Drain: BRIDGEWATER DRAIN **Drain #:** 245
Improvement/Arm: BRIDGEWATER - SECTION 2
Operator: JDH **Date:** _____
Drain Classification: Urban/Rural **Year Installed:** 1992

RE: Bridgewater Drain, Section 2 Arm

TO: Hamilton County Drainage Board

RE: Bridgewater Drain-Section 2

PROFILE TWO

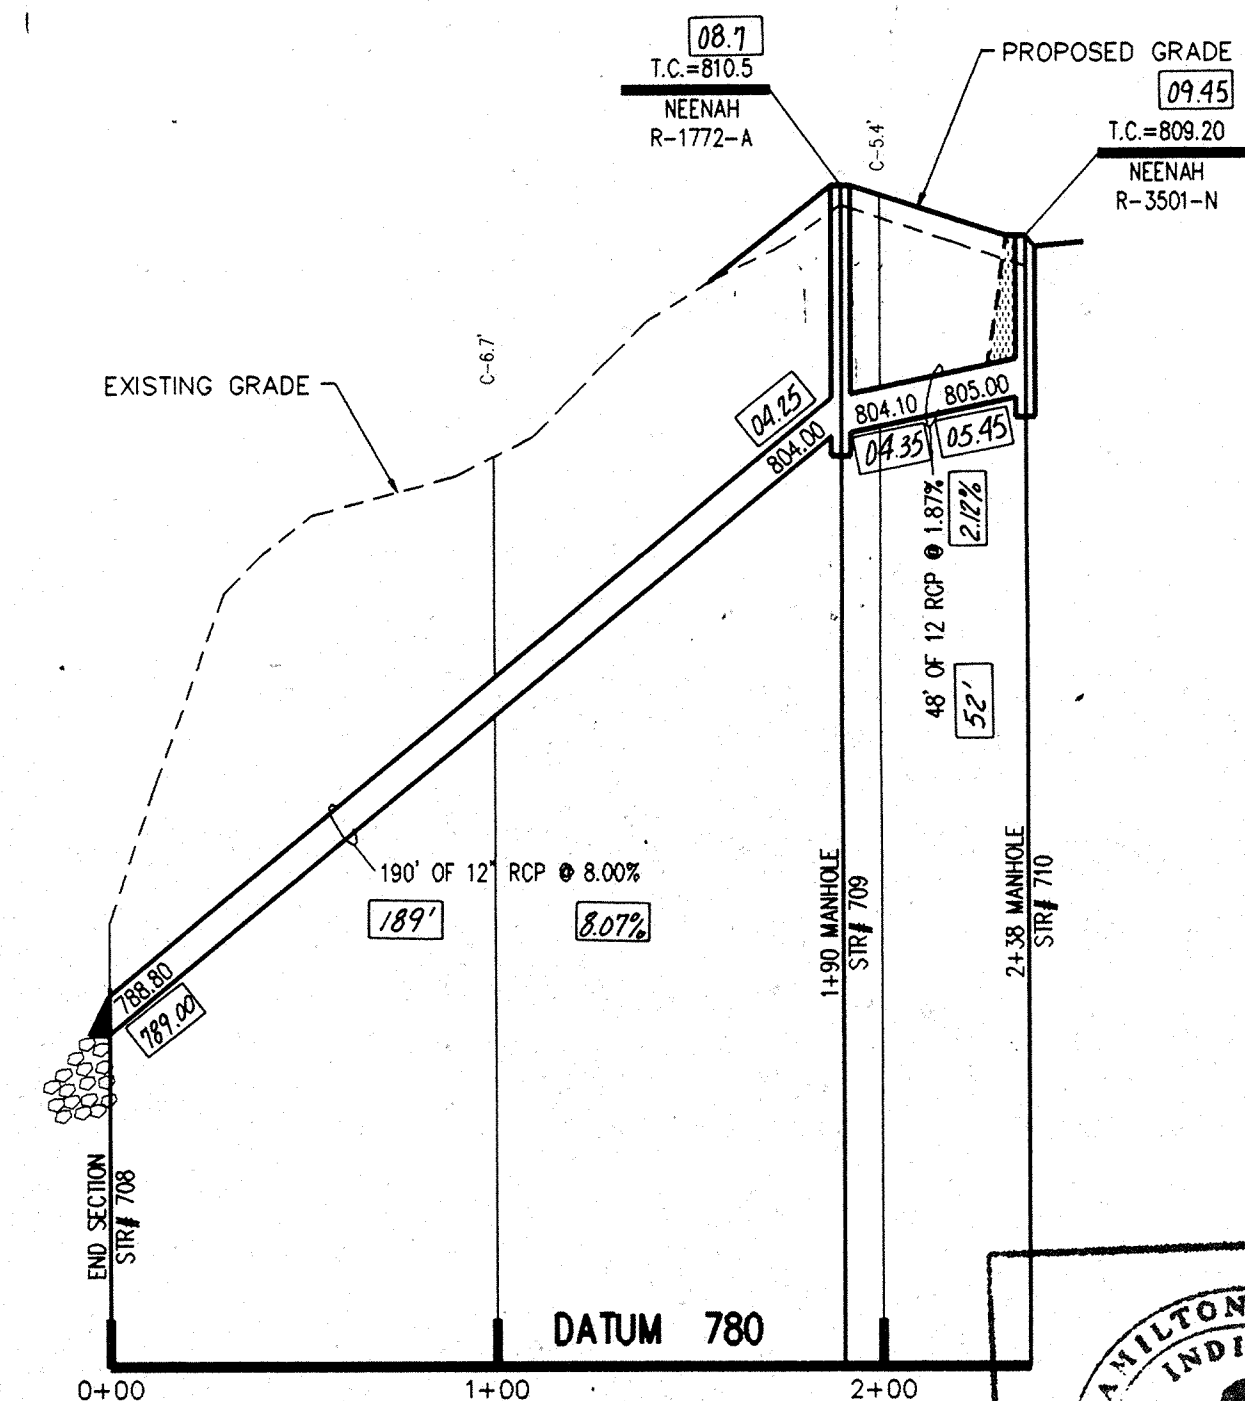
During construction, changes were made to the drain which will alter the plans submitted with my report for this drain dated September 24, 1992. The changes are as follows:

STR	710 to 709	12" RCP	lengthened from	48'	to	52 feet
STR	709 to 708	12" RCP	shortened from	190'	to	189 feet
STR	707 to 706	15" RCP	lengthened from	25'	to	30 feet
STR	705 to 704	15" RCP	lengthened from	200'	to	201 feet
STR	704 to 703	18" RCP	lengthened from	70'	to	71 feet
STR	703 to 702	18" RCP	lengthened from	80'	to	83 feet
STR	702 to 701	18" RCP	lengthened from	150'	to	151 feet

The length of the drain due to the changes described above is now 2,905 feet.
